Access Compliance Report

Public Rights-of-Way

Intersection ID: 18873	Main Street: SENECA_PL	Cross Street: WEDGEWOOD_DR	Location: SW
ADA ID: 9C4A8AEBC7D6	Ramp Type: Combination1Diag	Initial Pass/Fail: Fail	Overall Compliance: No
		Severity Score: 0

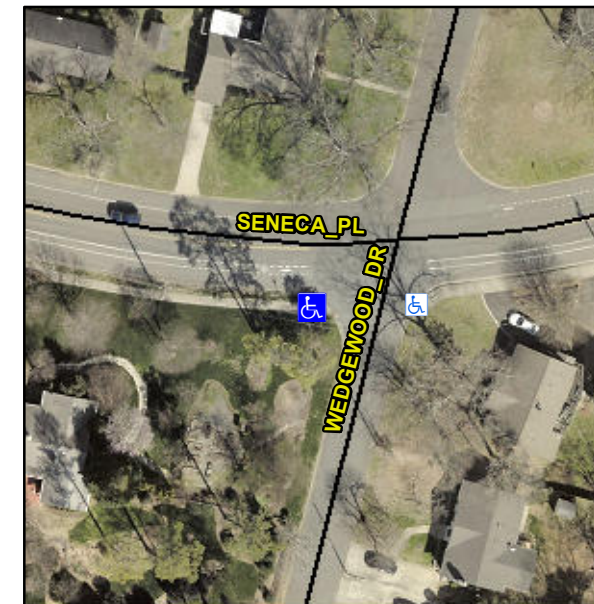
Not Found, R304.5.1, R304.5.1, R304.5.3, R304.3.2

Compliance	Description	Data	Compliance	Description	Data
N/A	Ramp Length LT (in)	40.0	N/A	Ramp Length RT (in)	31.0
No	Ramp Width LT (in)	45.0	Yes	Ramp Width RT (in)	53.0
Yes	Ramp Slope LT (%)	5.1	No	Ramp Slope RT (%)	10.5
No	Ramp XSlope LT (%)	2.5	Yes	Ramp XSlope RT (%)	1.7
N/A	Ramp Length (in)	36.0	Yes	Ramp Slope (%)	7.7
No	Ramp Width (in)	40.0	No	Ramp XSlope (%)	6.7
N/A	Flare Type LT	N/A	N/A	Flare Type RT	N/A
N/A	Flare Slope LT (%)	N/A	N/A	Flare Slope RT (%)	N/A
N/A	Flare Traversable LT?	N/A	N/A	Flare Traversable RT?	N/A
N/A	Landing Length (in)	N/A	N/A	DWS Provided?	N/A
N/A	Landing Width (in)	N/A	N/A	DWS Contrast?	N/A
N/A	Landing Slope (%)	N/A	N/A	DWS Length (in)	N/A
N/A	Landing X Slope (%)	N/A	N/A	DWS Full Width?	N/A
N/A	Landing Curb? (Y/N)	N/A	N/A	DWS Offset (in)	N/A
N/A	Shared Landing?	N/A			
N/A	Gutter Ponding?	N/A	N/A	Gutter Slope (%)	N/A
N/A	Gutter Lip Ht (in)	N/A	N/A	Gutter X Slope (%)	N/A
N/A	Painted X Walk1?	No	N/A	Painted X Walk2?	No

Remove & Replace Curb Ramp With Two New Directional Ramps or Equivalent.
